Anonymous Referee #1

## Overall Evaluation

### **Anonymous Referee #2**

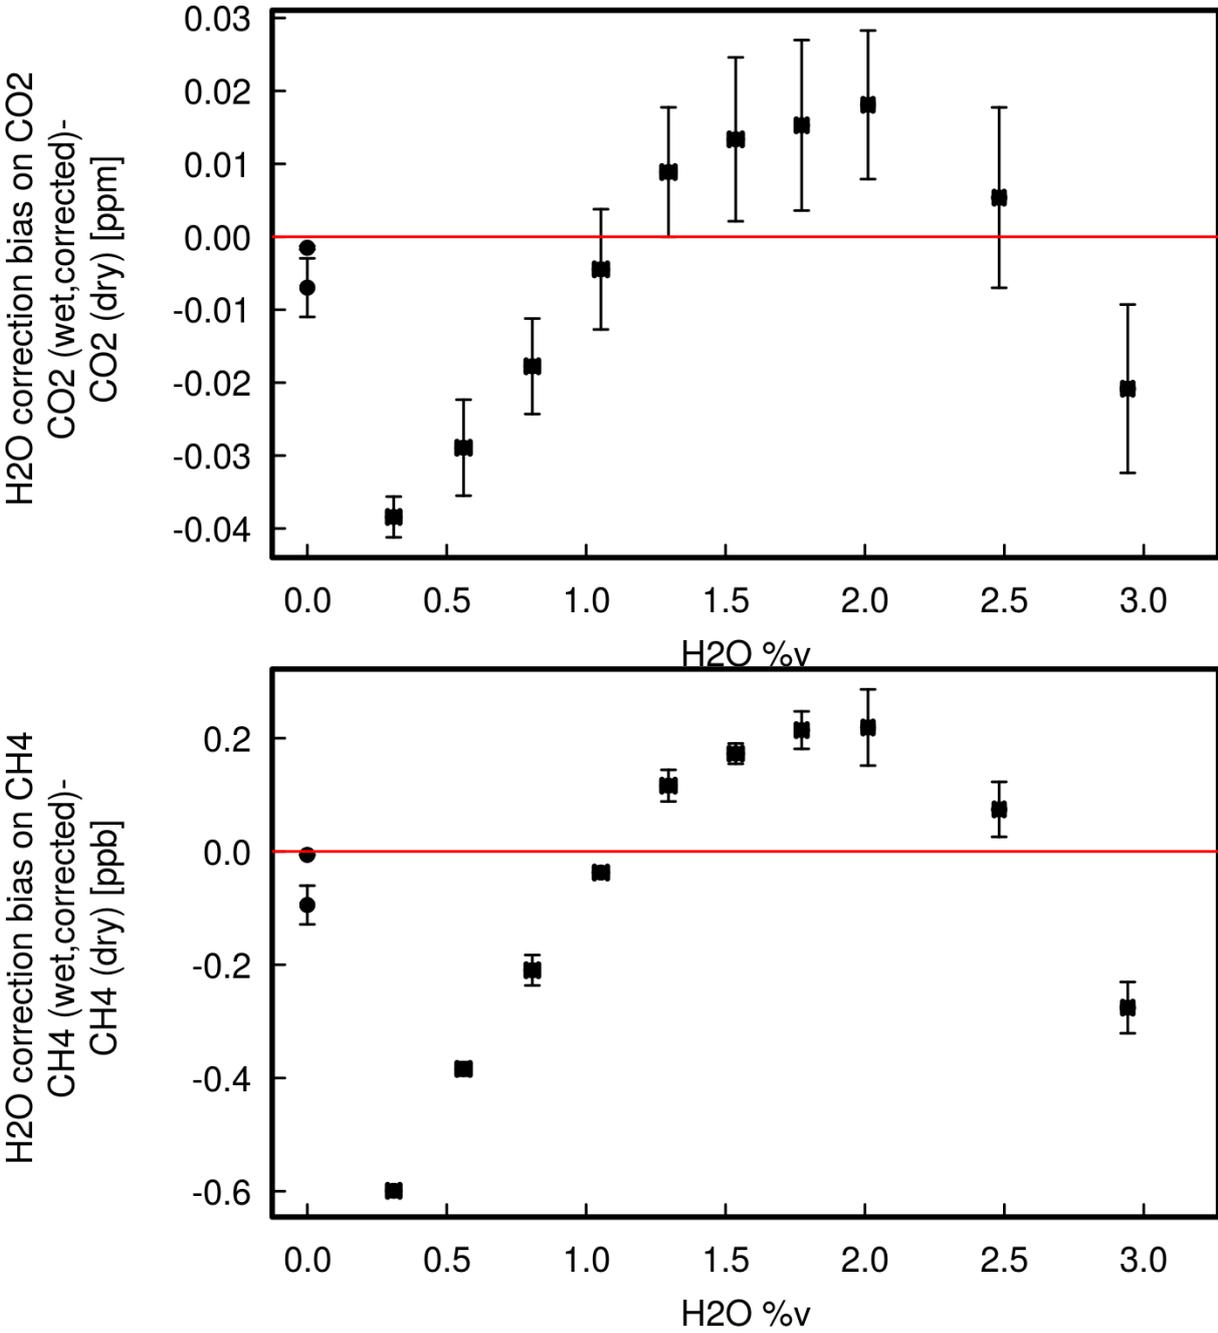
2.2 Measurements Line 125 – water vapour contents were corrected – up to what % was recorded at the sub-tropical latitudes? Is the correction linear to this level?

Humidity up to 4% was recorded by the Picarro instrument at subtropical latitudes, which is indeed beyond the typical range of water vapour expected for the instrument.

Picarro analyzers calculate a correction factor Cr as a quadratic function according to Eq. 1:

For this particular instrument, the quadratic factory water vapor correction had been overridden prior to the campaign to fit the ICOS Metrological Laboratory bench tests shown on the Figure below. The values are given in Table 1.

The difference between corrected and uncorrected measurements are shown in the Figure below. At 4% humidity, the extrapolated CH<sub>4</sub> correction is -0.8 ppb, to be compared to 0.6 ppb correction at 3% humidity. For CO<sub>2</sub>, we calculated a correction of 0.20 ppm at 4% vs 0.15 ppm at 3%. The extrapolation beyond 3% humidity does not occur in a strongly non-linear range of the correction function. We are therefore confident that the impact of potential errors in the water vapor correction at high humidity has no significant effect on our results. We added a summary of these elements in the manuscript text.
